Staff Report

Report To: City Council
Report From: Sabine Robart, Intermediate Planner
Meeting Date: August 26, 2019
Report Code: CS-19-107
Subject: Recommendation Report Respecting Zoning By-law
Amendment No. 28 and Site Plan Approval ST2018-016
1200 16th Avenue East (API Hotel)

SITE PLAN

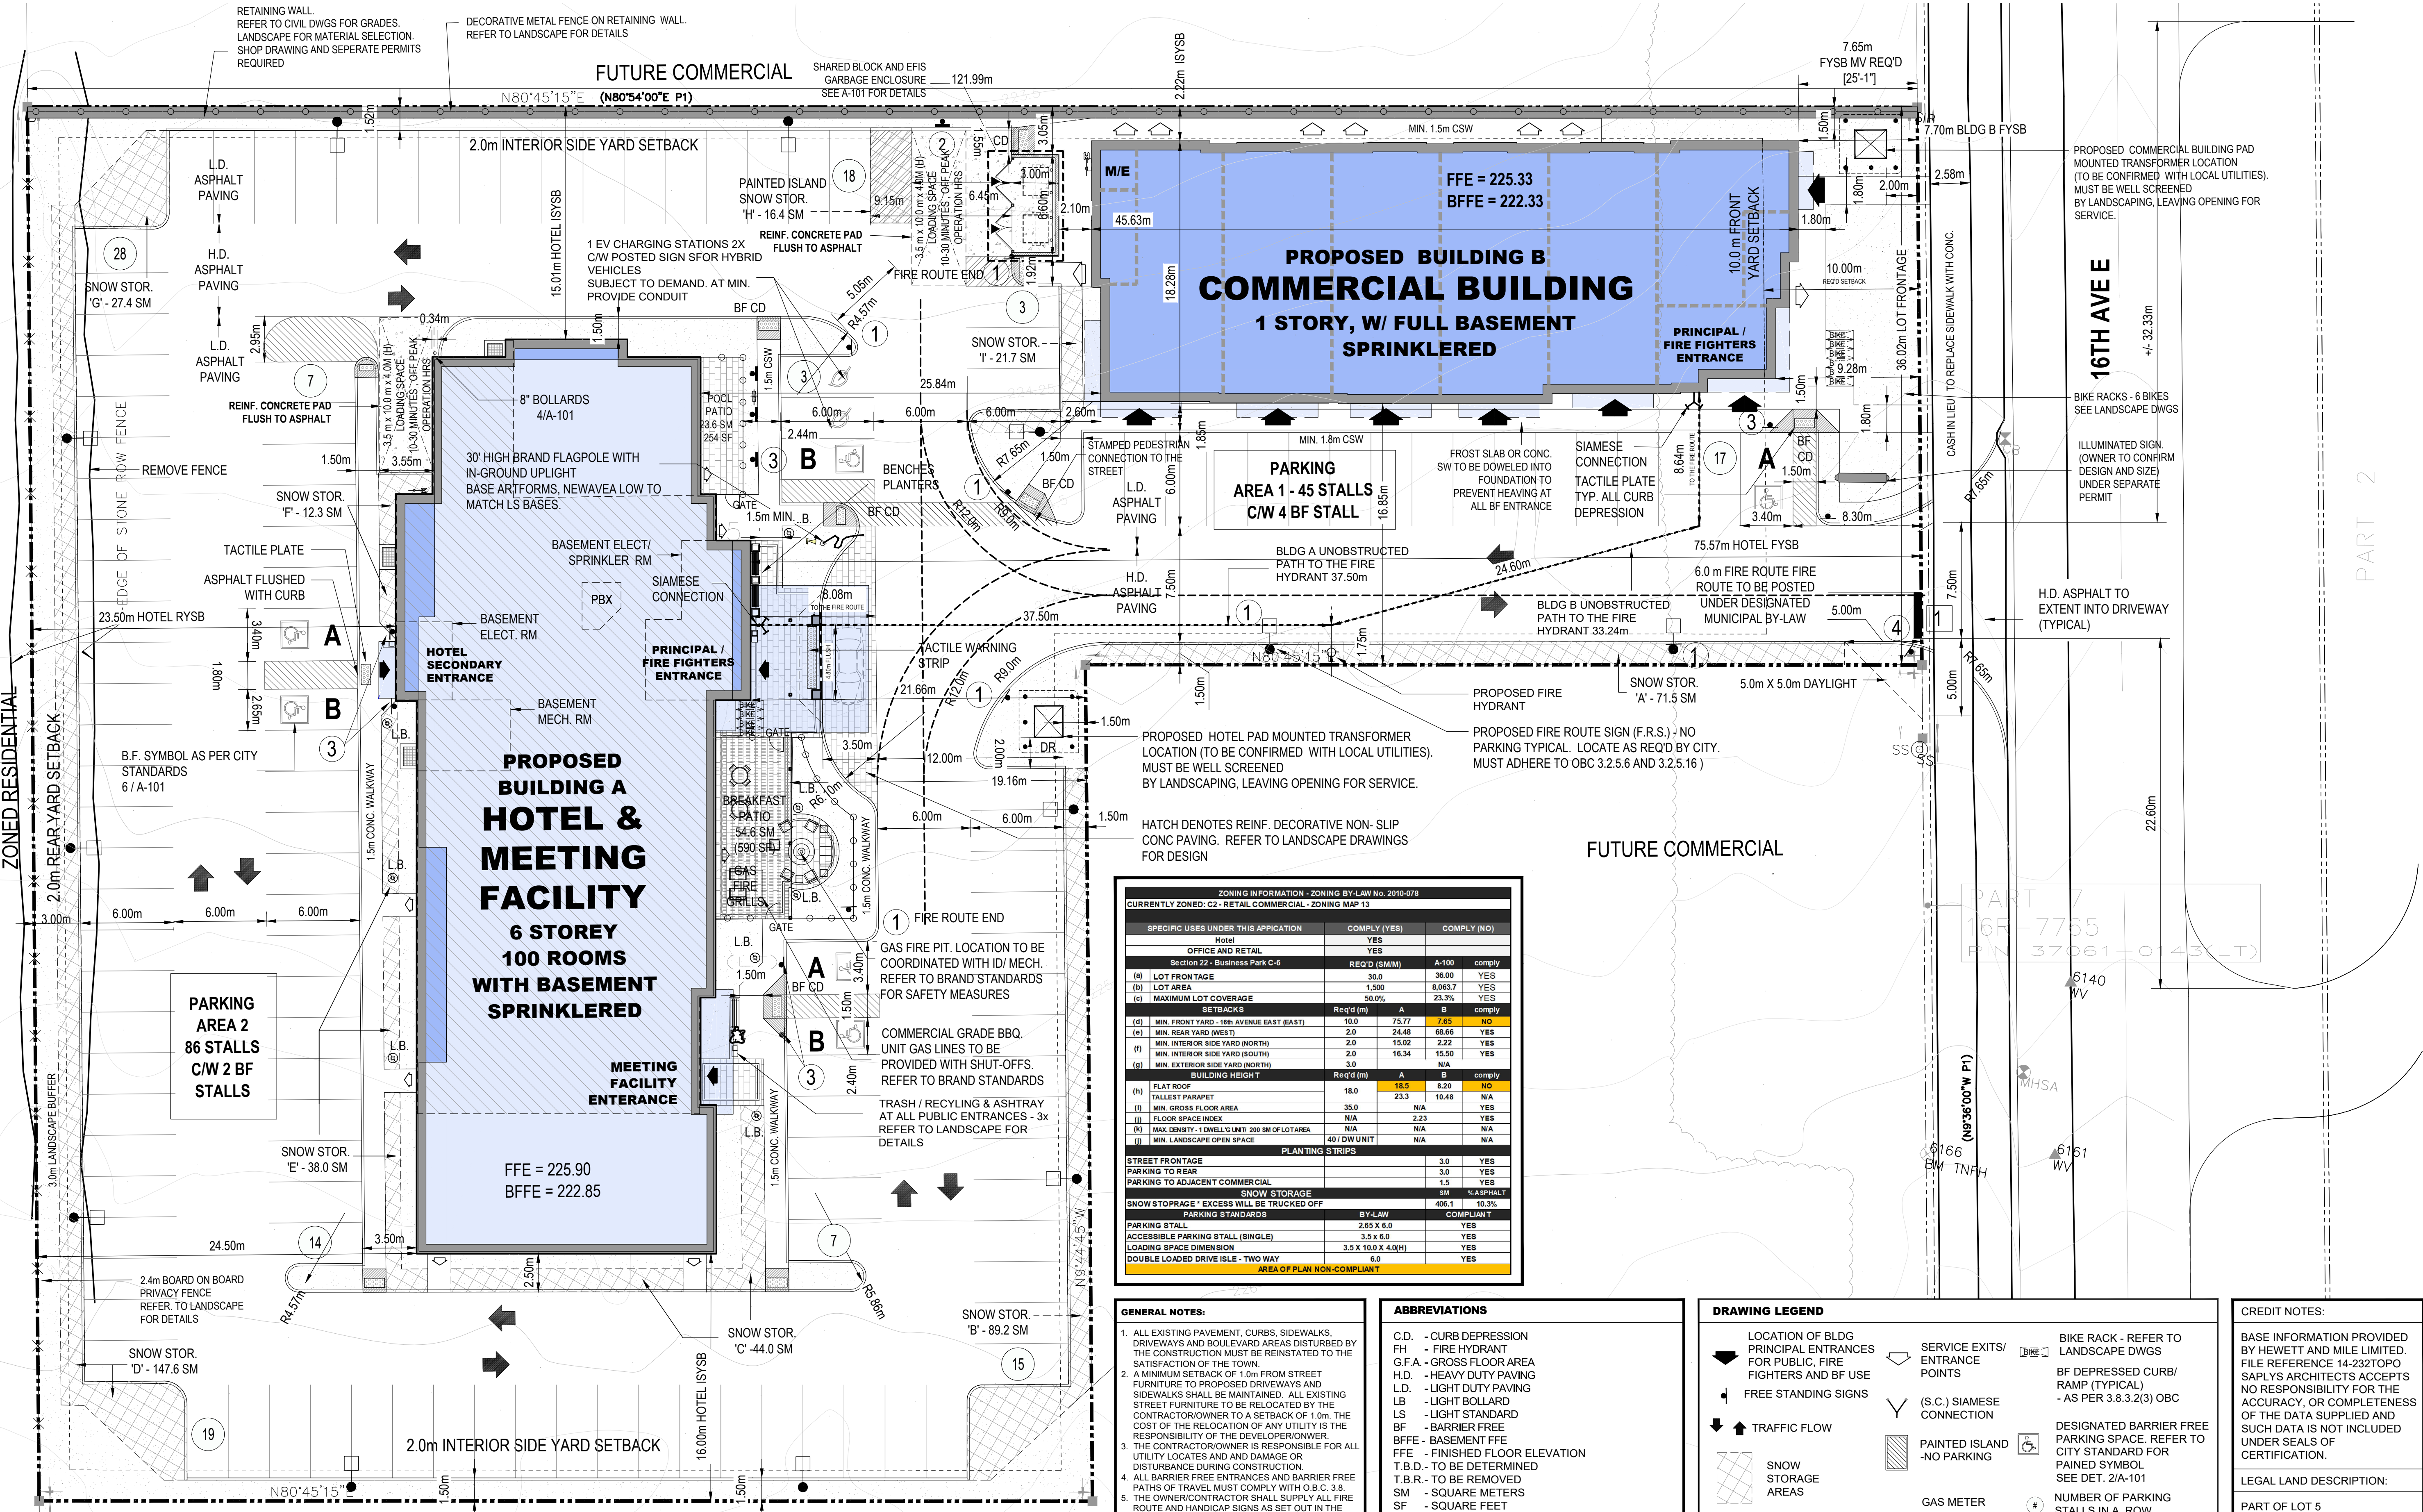
Design Aspect	Policy Context/Staff Comments
General Layout	The commercial building is located at the front of the L-shaped parcel with parking to the side and rear of the lot. Keeping development at the front of the lot allows for the development of a consistent streetscape.
Parking Layout	The parking lot layout is safe and functional.
Pedestrian Access and Connectivity	<p>The external sidewalk on the west side of 16th Avenue East connects to an internal sidewalk that travels east/west along the front of the commercial building. The sidewalk connects from the commercial building to the hotel via a dropped curb with tactile walking surface indicators and a painted pedestrian crosswalk between the concrete sidewalks. The sidewalk continues along the east side of the hotel to the main entrance. A concrete sidewalk is also located on the west side of the hotel. The sidewalks on the east and west side of the hotel terminate in a dropped curb and tactile walking surface indicators at the perimeter of the hotel.</p> <p>It is recommended as a condition of approval that tactile (TWSI) plates be red, cast iron per City Standards and be provided where ever there is a change in grade from the on-site sidewalk to the drive aisles and parking areas.</p>

Garbage & Recycling	<p>A garbage enclosure with a 2.0m high fence is proposed on the northeast corner of the commercial building. The garbage enclosure will mainly serve the commercial building. The hotel will manage its garbage within the building.</p>
Snow Storage	<p>Snow storage is shown on a portion of the southern property boundary, in the corners of the property and on the concrete boulevard between the buildings and the concrete sidewalks.</p> <p>Through the application process, Staff have noted to the applicant that snow storage on site might be insufficient in the event of a major snowfall. The applicant has indicated that 12% of total asphalt is dedicated for snow storage. This is allocated to</p>

Fire Prevention comments noted that the fire department connection on the commercial building is located at the west end. It should be located on the south east corner, near the principal / fire fighters entrance. Comments from Fire Prevention on the revised submission note that there are no outstanding issues.

- a. That TWSI plates be red, cast iron per City Standards be provided where there is a change in grade from the on-site sidewalk to the drive aisles and parking areas.
- b. That revised submission materials (plans, studies, drawings) be submitted to the City as required to capture additional items arising out of ongoing project due diligence to the satisfaction of the Community Services Department and the Engineering and Public Work Department.
- c. That a capital contribution of \$43,096.49 be received prior to the execution of the site plan agreement.
- d. That on-site LED lighting should be specified with a colour temperature (CCT) of 3000K (warm white). The lighting will be downward facing and dark-sky compliant.
- e. That the applicant is requested to consider the installation of benches intermittently along the interior paths of travel for pedestrian rest areas.
